CONCRETE MASONRY RESTORATION

RE: Oak Park River Forest Parking Structure – Stair/Elevator Enclosure  
**Additional Work Item**

Walker  
Revisions  
11/16/21

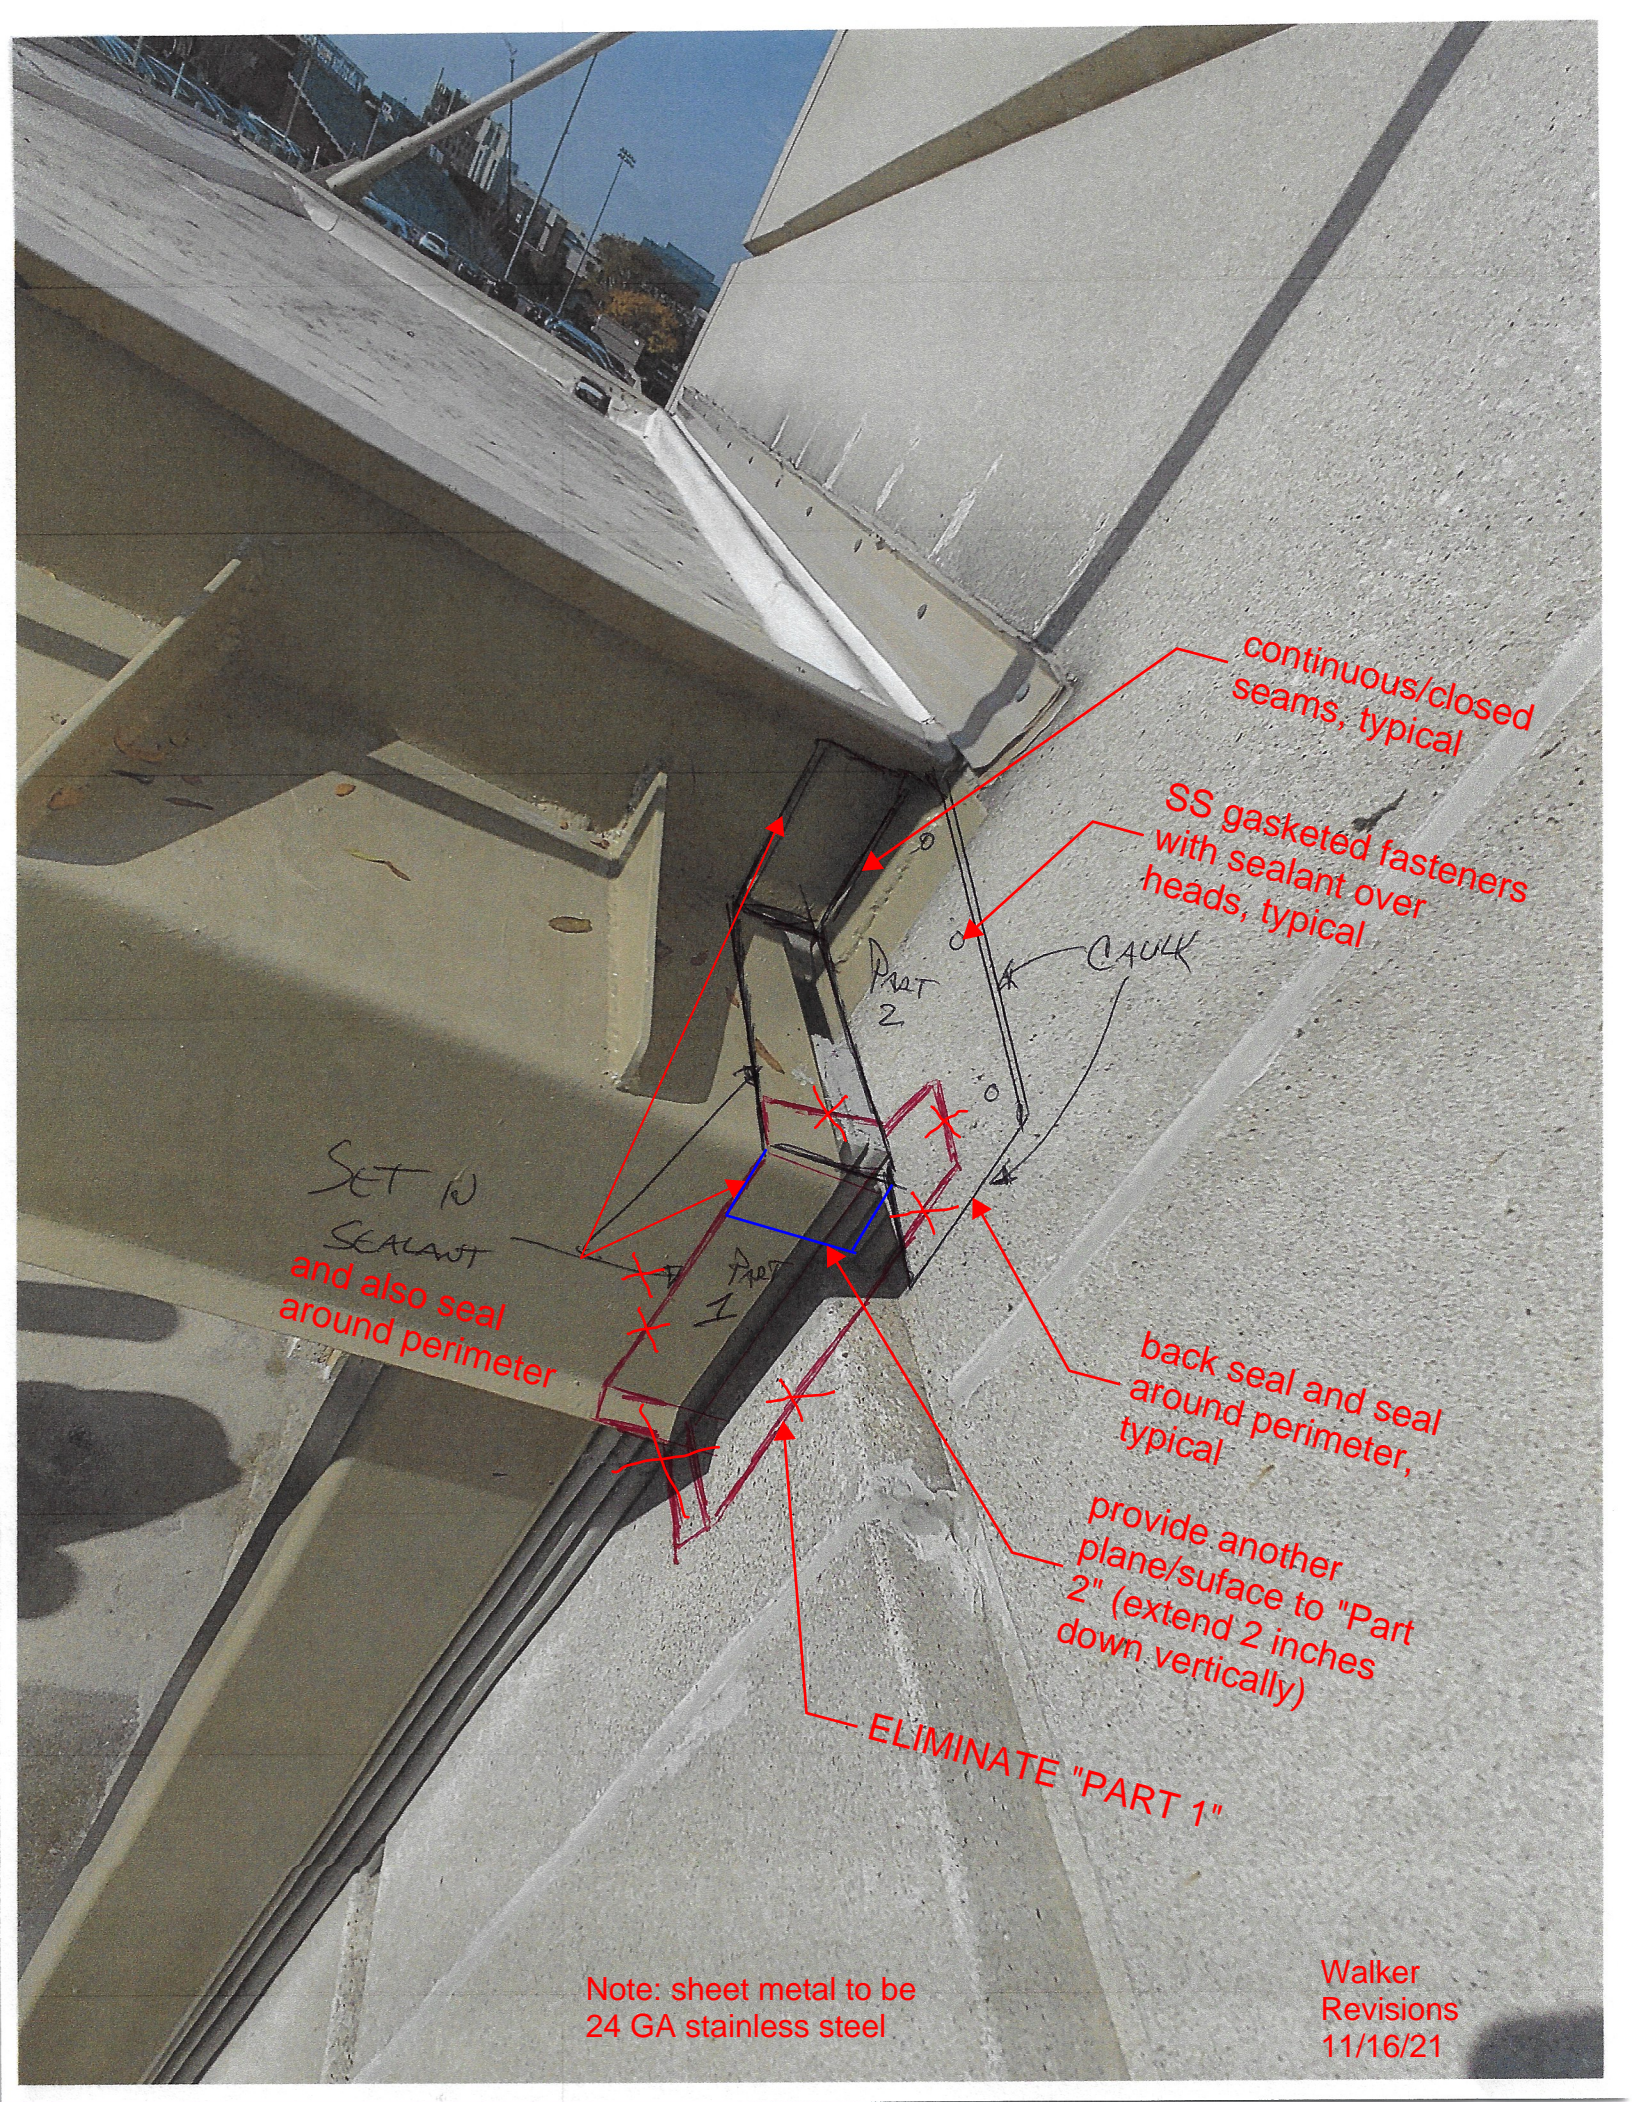
The additional cost to the project to furnish and install two (2) custom pieces of sheet metal flashing including approved Tnemec paint at the east and west ends of the structure where the canopy abuts the façade shall be THREE THOUSAND SIX HUNDRED FIFTY AND 00/100 (\$3,650.00)

continuous/closed seams, typical

SS gasketed fasteners with sealant over heads, typical

back seal and seal around perimeter, typical

provide another plane/surface to "Part 2" (extend 2 inches down vertically)

ELIMINATE "PART 1"

SET IN SEALANT and also seal around perimeter

Note: sheet metal to be 24 GA stainless steel
